RE: MAUKA PARCEL
Special Permit Application (SPP12-000138)
Applicant: Connections New Century Public Charter School and Community Based
Education Support Services
Request: To Develop a K to 12 Charter School Campus with Dorm Facilities,
Intergenerational Programs, a Sustainable Agriculture Program and a
Forestry/Conservation Program
Tax Map Key: (3)1-5-006:141

COUNTY OF HAWAI‘I PLANNING DEPARTMENT
BACKGROUND REPORT

CONNECTIONS NEW CENTURY PUBLIC CHARTER SCHOOL/CBESS
SPECIAL PERMIT APPLICATION NO. 12-000138 (SPP 12-000138)

Figure 1: Location of Kaumana Cave within TMK 2-5-06-4, surveyed by Island Survey for the Punalako Extension & Widening EIS, 1993, p34 (omitted from the current draft EA)

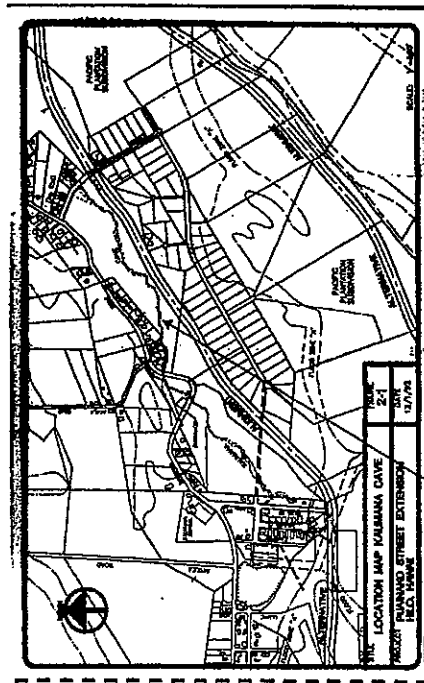
1. The survey showing the location of Kaumana Cave under the development was omitted from the Draft EA. This is a significant omission, given that the cave was surveyed by Island Survey as part of the Puainako Extension EIS (1993, p34). Although the Draft EA sites the Puainako Extension EIS, the map showing the cave location was inexplicably left out. An accurate map of the cave is crucial for designing surface structures to avoid safety issues during construction and to prevent damage or pollution to the cave. (see Figure 1 below)

Since the planners knew that Kaumana Cave existed within the project site, it is imperative that they include the cave location in the plan with an assessment of potential impacts. A map showing the cave location was included in the 1993 Puainako Street Extension EIS, copied here as Figure 1. Comparison of this with the planned Charter School shows that most of the school buildings, roads and septic systems were placed over or close to Kaumana Cave. Figure 2 shows the school plan from the Draft EA with red arrows showing the approximate location of the cave.

Figure 3: TMK 2-5-06-4 showing the approximate location of Kaumana Cave with 100 foot suggested mitigation boundaries to avoid significant environmental impact to the cave and hazard to construction equipment

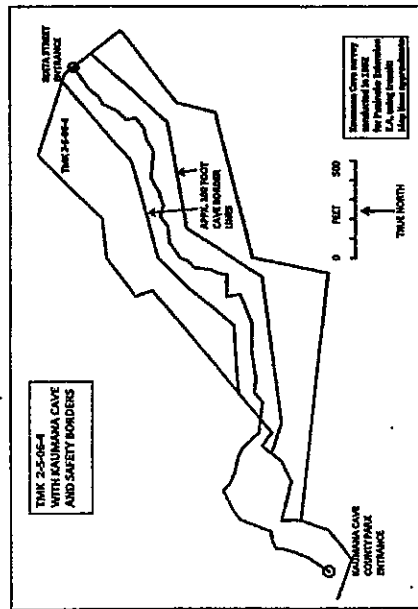
The 1993 Puainako Extension EIS, Appendix F, Drainage gives a detailed hydrological analysis of the area which should be used as the basis for the flood hazard assessment in the Final EA and EIS.

Figure 4: Flood zone map with dashed lines showing approximate location of Kaumana Cave (section below Editha Street based on survey by the Hilo Lions Club. In Hilo Tribune Herald, Mar. 21, 1954): The cave forms an underground flood conduit during heavy rains.

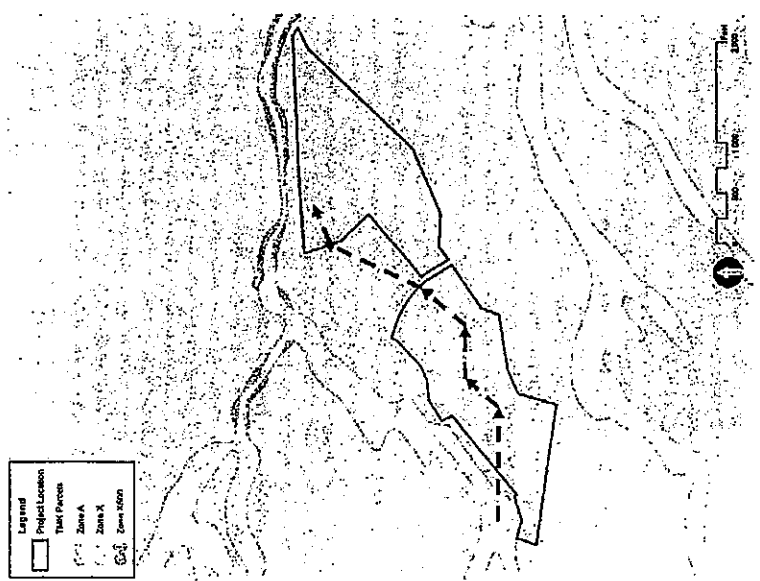
Based on this, the draft EA states that the project area is not in a flood zone. This ignores the actual situation, that Kaumana Lava Flow followed an intermittent stream bed from above Kaumana Village to below the proposed development. This makes Kaumana Cave an underground flood channel. Figure 4 below shows the FEMA flood map with the approximate course of Kaumana Cave shown as red dashed arrows. During extended or heavy rainfall, which occurs several times each year, water runs into Kaumana Cave from intermittent streams and from a runoff channel that diverts Kaumana Road drainage into the cave in Kaumana Village. Water partially floods the cave, and some of this flood water exits from the Editha Street entrance, and floods the area downslope, including the lower TMK (2-5-06-141). Placing buildings, roads, parking areas, and septic drainage systems over this flood channel has a major potential for significant environmental impact.

Figure 6: Kaūmāna Cave showing locations of major roof collapses and areas with abundant 'ohi'a roots and cave adapted invertebrate species.

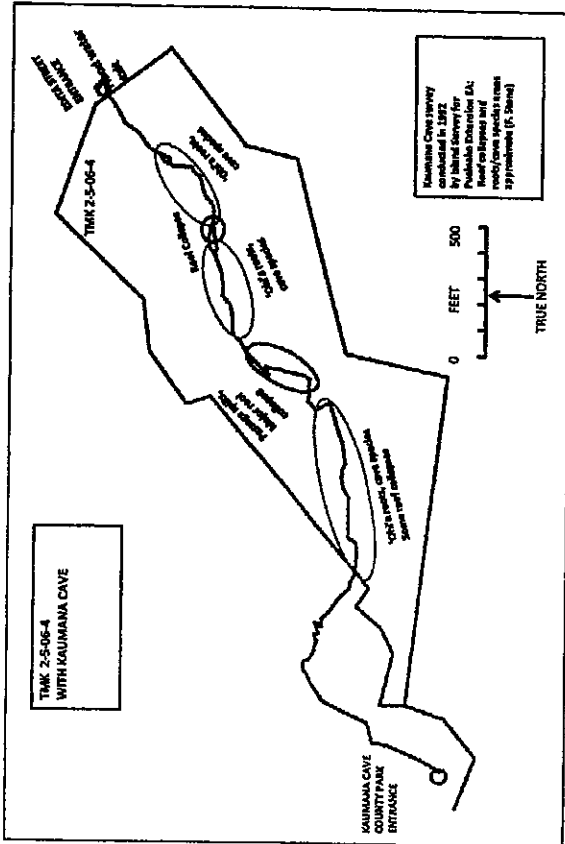
This brief description is excerpted from the Puimako Extension EIS, App. D. It should not be substituted for a thorough cave survey and inventory which should be included in a Final EA and EIS. (See Figure 6)
